PROJECT: DURKIN PARK ELEMENTARY SCHOOL ANNEX

PBC NO.: 05540

ISSUE: ISSUE FOR ADDENDUM NO. 1

TITLE: UPDATED COURTYARD PLAN

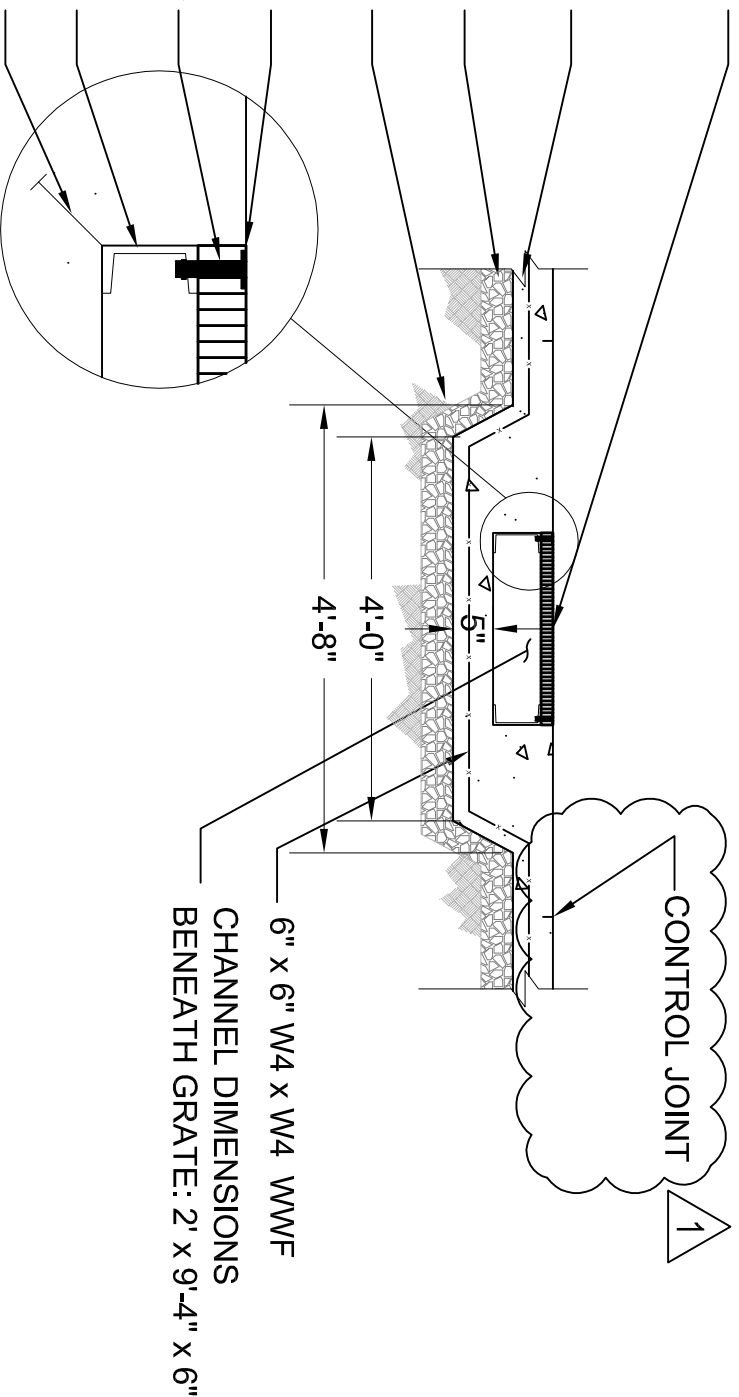
COMMENTS: REFERENCE DETAIL 1 OF C2.0

1 ADA GRATE IN COURTYARD
NTS

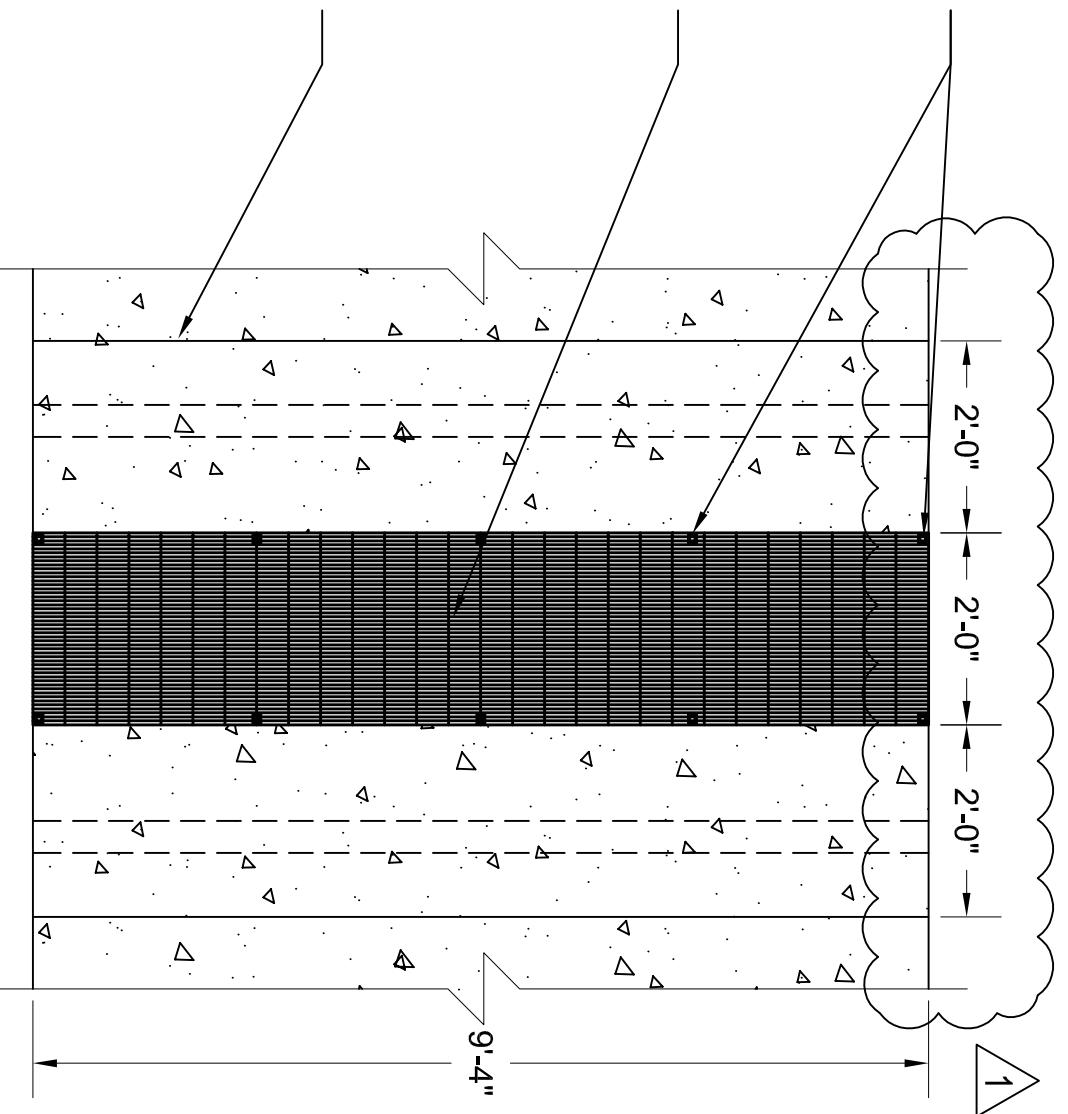
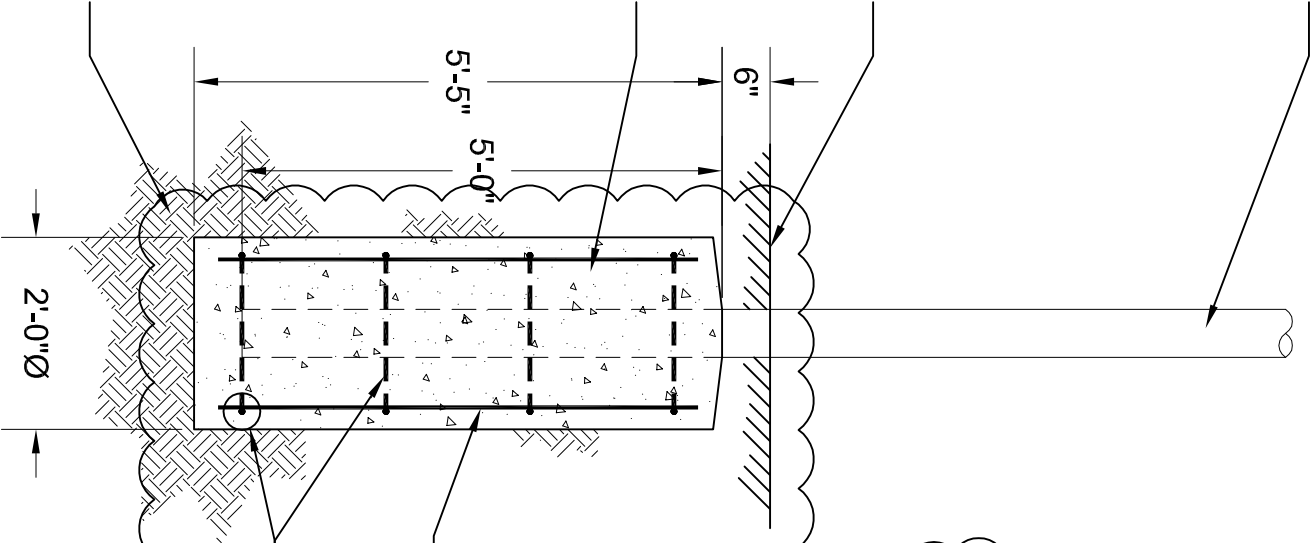
ADA COMPLIANT MCNICHOLS
GALVANIZED CUSTOM ANCHOR
BLOCK GRATE FASTENERS, OR
APPROVED EQUAL

2' x 9'-4" x 1'-1/2" ADA COMPLIANT
PEDESTRIAN GRATE, MCNICHOLS
GCM-2 SERIES, GALVANIZED STEEL
BAR GRATE AND ANCHOR BLOCK
FASTENERS, OR APPROVED EQUAL

CONCRETE WALK AND BASE
5" MIN THICKNESS

CONCRETE WALK AND BASE
5" MIN THICKNESS

CA-6 COMPACTED BASE
4" MIN THICKNESS

EXISTING SUBGRADE COMPACTED
TO 95% MODIFIED PROCTOR

GRATE TO BE FLUSH WITH
ADJACENT SIDEWALK
MCNICHOLS ANCHOR BLOCK
FASTENING SYSTEM AND ASSEMBLY

C6 x 12 GALVANIZED STEEL
SUPPORT CHANNEL
3" STUDS @ 12" O/C RECESSED

CHANNEL DIMENSIONS
BENEATH GRATE: 2' x 9'-4" x 6"

DOWNSPOUT SUPPORT FOUNDATION
NTS

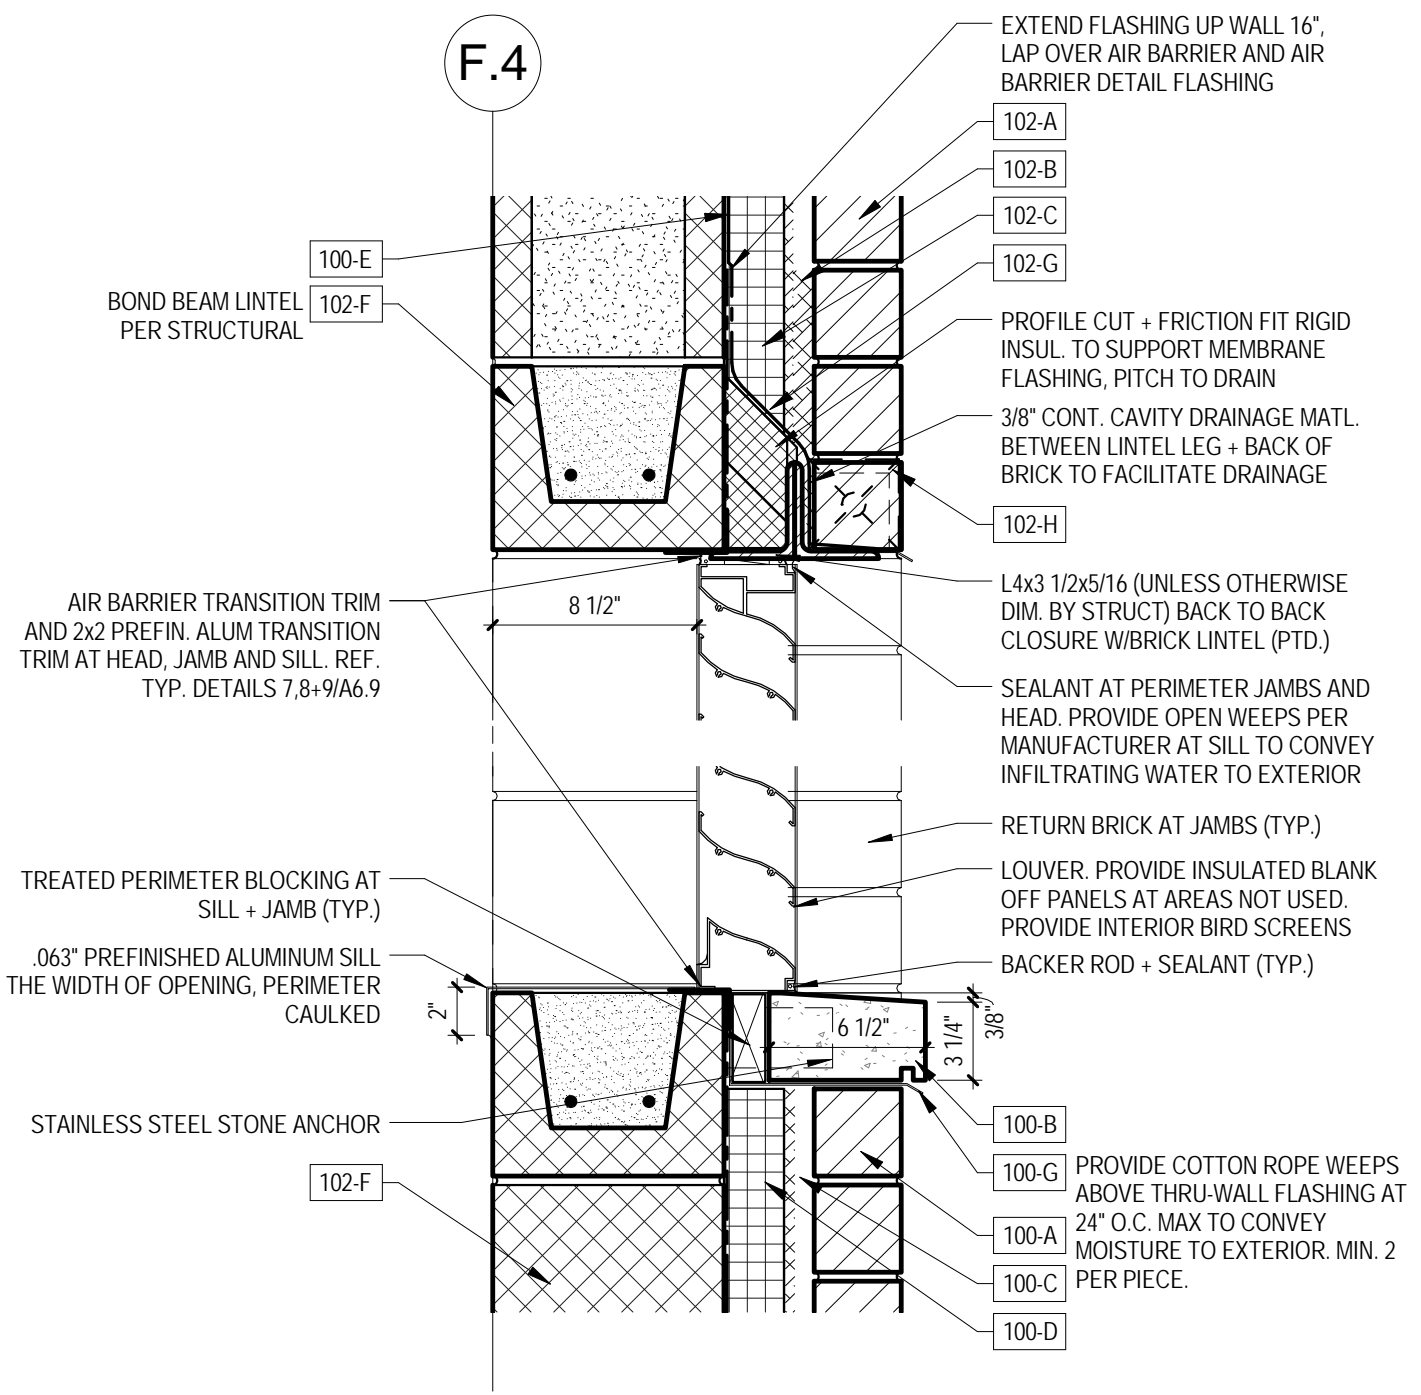
ROUND HSS 6 x 1/2 STEEL PIPE
COLUMN; HOT DIPPED GALVANIZED.
PROVIDE MOUNTING PLATE AND
CONCRETE SONOTUBE PIER AT ALL
DOWNSPOUT LOCATIONS. REFER
TO ARCHITECTURAL PLANS FOR
LENGTH AND CONNECTION
DOWNSPOUT.

CONCRETE FOUNDATION
SET IN 24"Ø SONOTUBE

1. REFER TO SHEETS C2.0 AND C3.0 TO DETERMINE LOCATION AND ORIENTATION OF DOWNSPOUT SUPPORTS.
2. DOWNSPOUT SUPPORT LOCATION TO BE ALIGNED WITH RAINWATER PLATE ~~DIRECTLY DOWN SPOUT.~~
3. REBAR TIES SHALL BE #4 AT 18" O.C., EPOXY COATED.
4. ~~CONCRETE FOUNDATION TO BE MIN 3,500~~ CONCRETE AT 28 DAY STRENGTH, AIR ENTRAINED. BOTTOM OF CONCRETE FOUNDATION TO BE SET MINIMUM 6'-0" BELOW SURROUNDING GRADE.
5. CONTRACTOR TO PROVIDE SHOP DRAWING OF DOWNSPOUT SUPPORT AND MATERIALS FOR ENGINEER'S APPROVAL PRIOR TO CONSTRUCTION.

VERTICAL REBAR SHALL BE #5
BARS, MINIMUM 8 BARS AT 5'
LONG.

← PARTIAL ROOF FRAMING PLAN
 1/8"=1'-0"

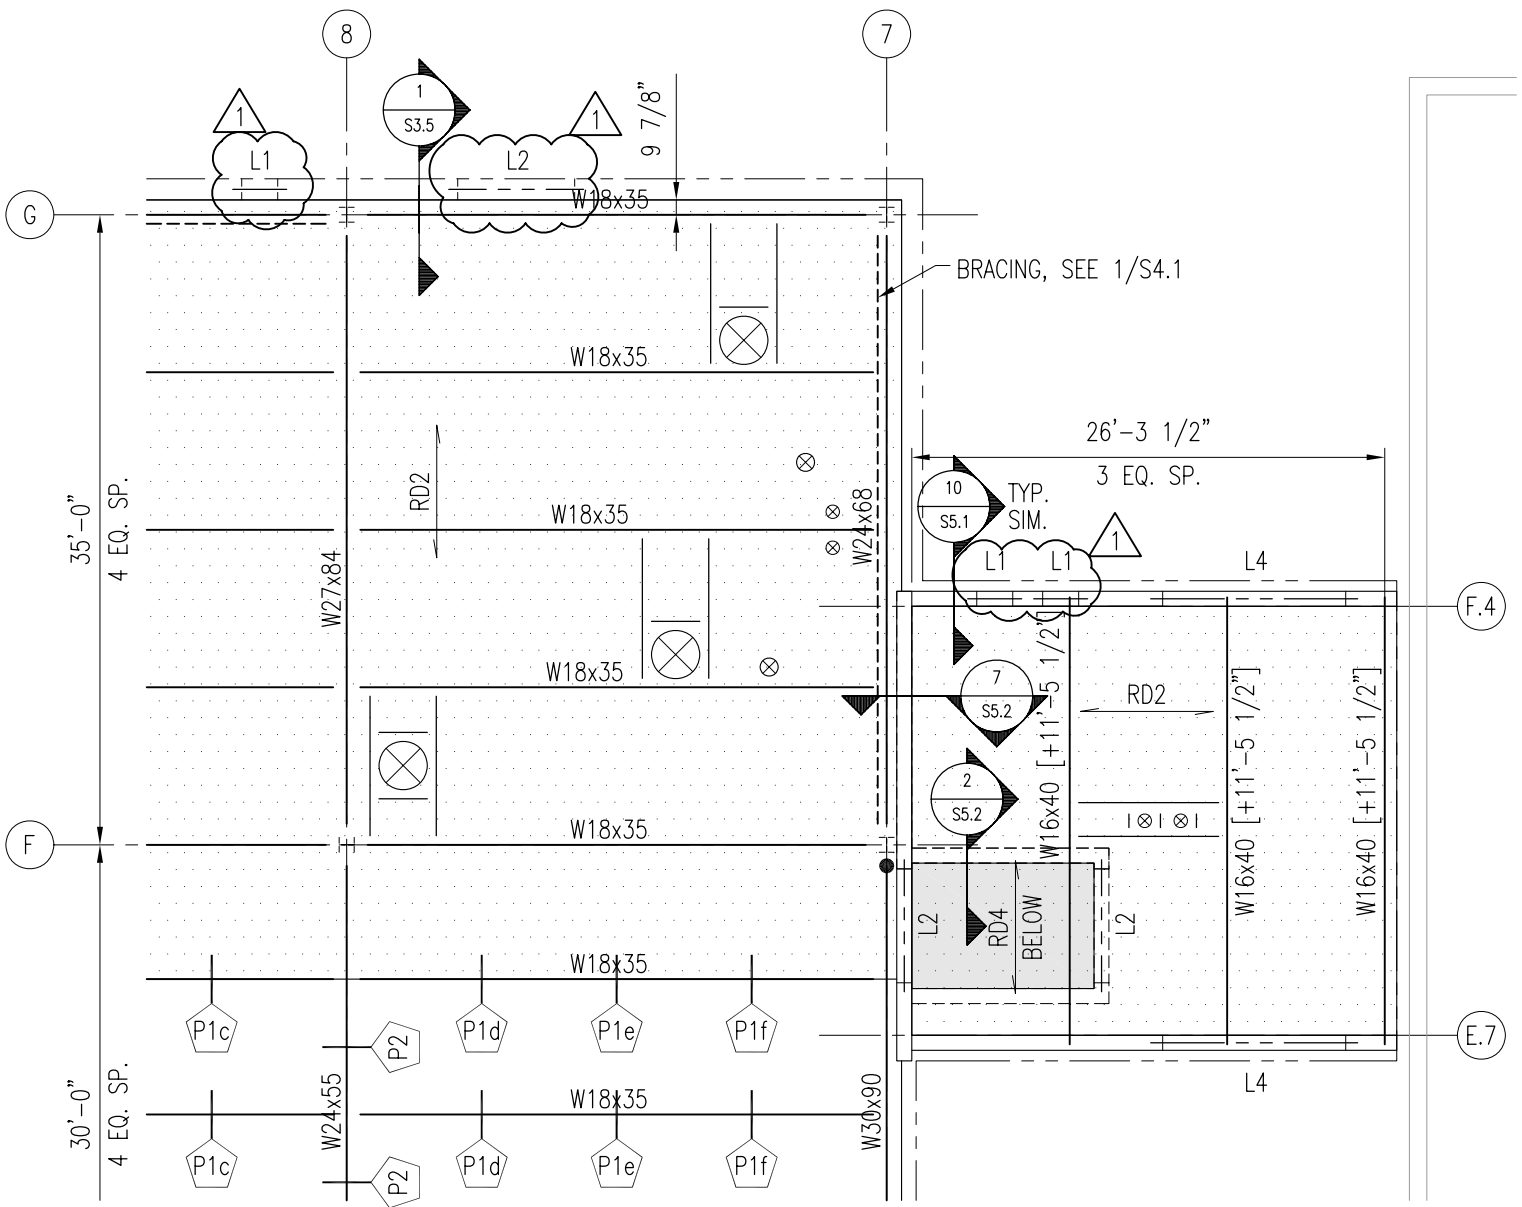
9. SEE DETAILS 5/S3.2, 6/S3.2, 7/S3.2 AND 8/S3.2 FOR TYPICAL FRAMING AT OPENINGS. COORDINATE SIZE AND LOCATION OF ALL OPENINGS/PENETRATIONS WITH ARCHITECTURAL AND M.E.P. DRAWINGS.

10. "Lx" INDICATES STEEL LINTEL BELOW. SEE SCHEDULE ON SHEET S5.1, AND ELEVATIONS ON SHEET S6.1.

11. P1x INDICATES 9"x18" MAX. WEB PENETRATION IN BEAM AT 1/4th POINTS OF BEAM SPAN. SEE DETAIL 8/S3.1 FOR MORE INFORMATION. COORDINATE WITH ARCH. AND MEP DWGS. REGARDING THE LOWER CASE "x" DESIGNATION.

12. P2 INDICATES 9"x18" MAX. WEB PENETRATION IN GIRDER AT MID POINTS BETWEEN BEAMS. SEE DETAIL 8/S3.1 FOR MORE INFORMATION.

2 MOMENT FRAME ELEVATIONS

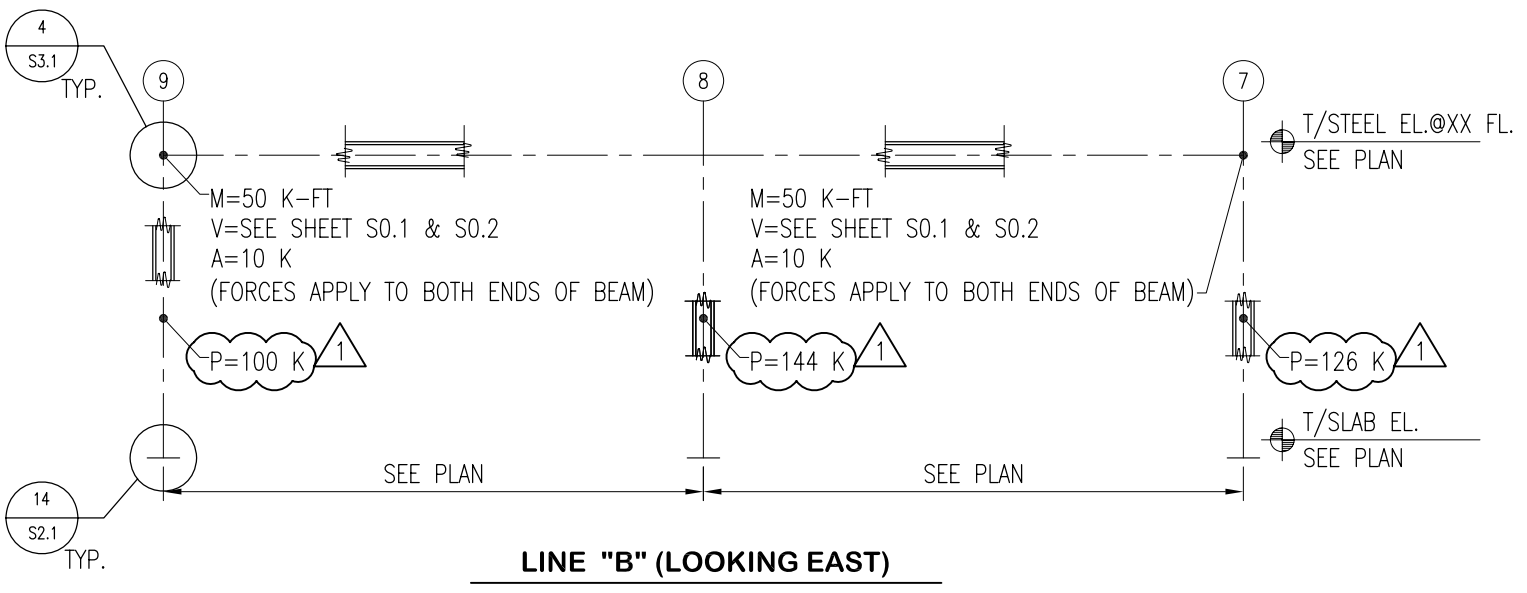
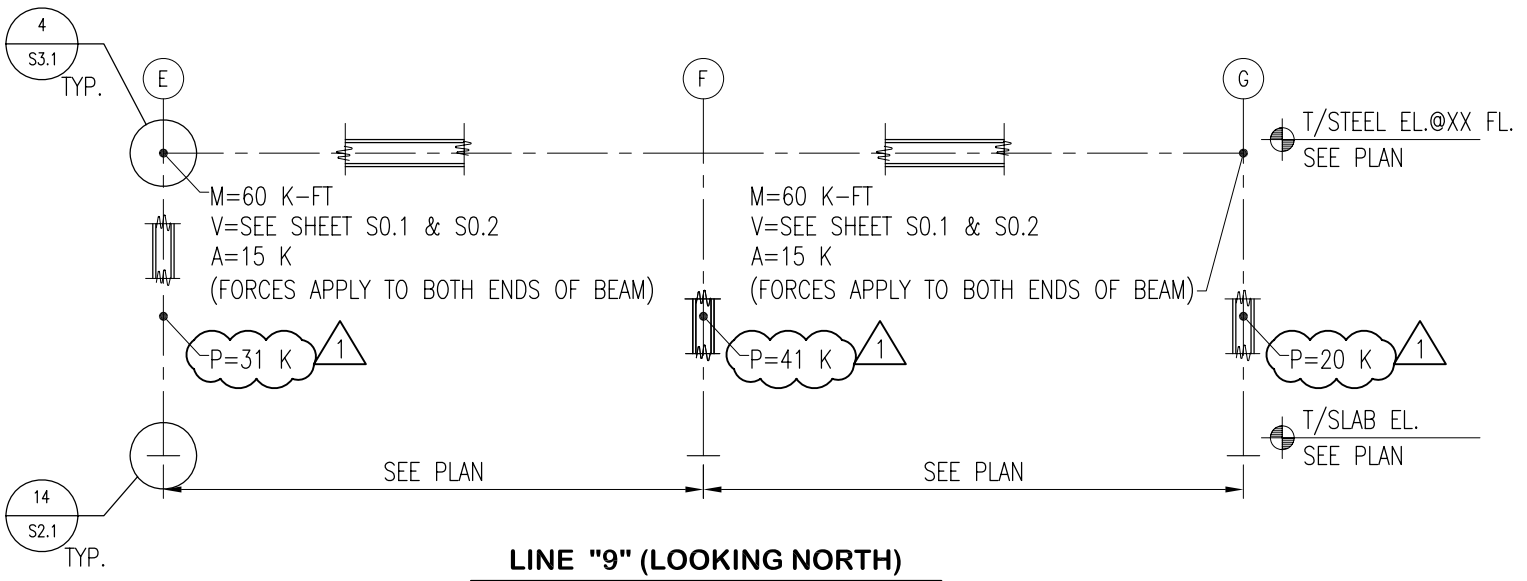
1. SEE PLAN FOR BEAM/COLUMN SIZES AND ALL ELEVATIONS AND DIMENSIONS.
2. ALL INDICATED LOADS ARE UNFACTORED.
3. M = MOMENT V = SHEAR & A = AXIAL (APPLIES TO BOTH ENDS OF BEAMS)

4. P = AXIAL LOAD IN COLUMN ONLY FOR THE DESIGN OF MOMENT FRAME DOUBLER PLATES.

6 SINGLE PIPE ROOF PENETRATION DETAIL
M6.5 NO SCALE

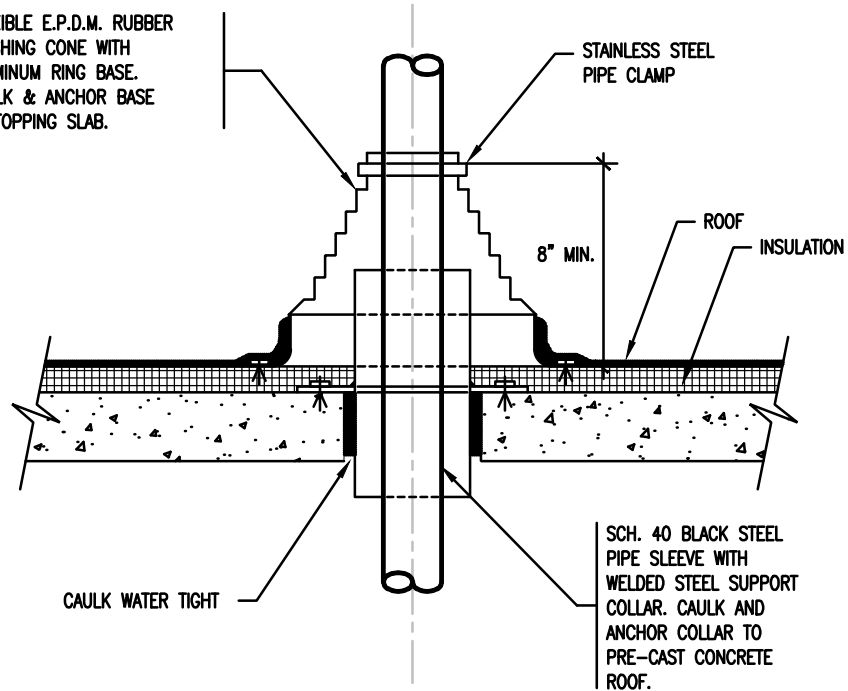
FLEXIBLE E.P.D.M. RUBBER
FLASHING CONE WITH
ALUMINUM RING BASE.
CAULK & ANCHOR BASE
TO TOPPING SLAB.

MSK-7

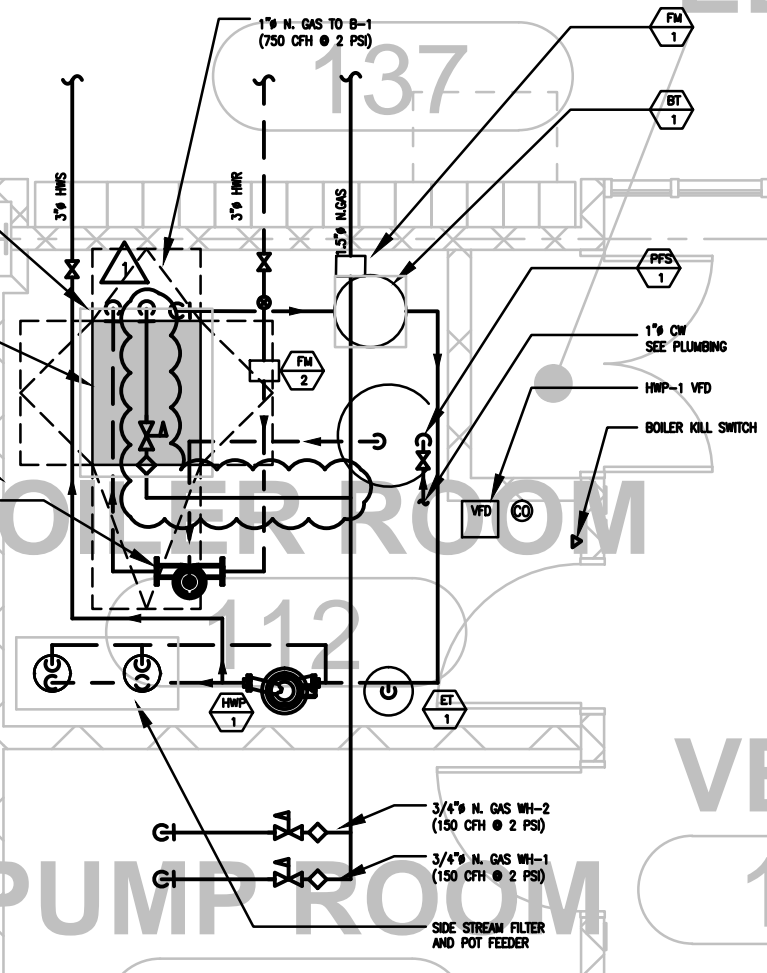
4" CONCRETE HOUSEKEEPING PAD SHALL EXTEND 4" BEYOND EACH EDGE OF EQUIPMENT. (TYPICAL)

SIGN TO BE MOUNTED NEXT TO BOILER "IN CASE OF BOILER FAILURE, HEATING REDUNDANCY IS AVAILABLE AT ROOFTOP UNITS (RTU). RTU DISCHARGE AIR TEMPERATURE SHALL BE RESET MANUALLY BY TRAINED MAINTENANCE PERSONNEL ONLY."
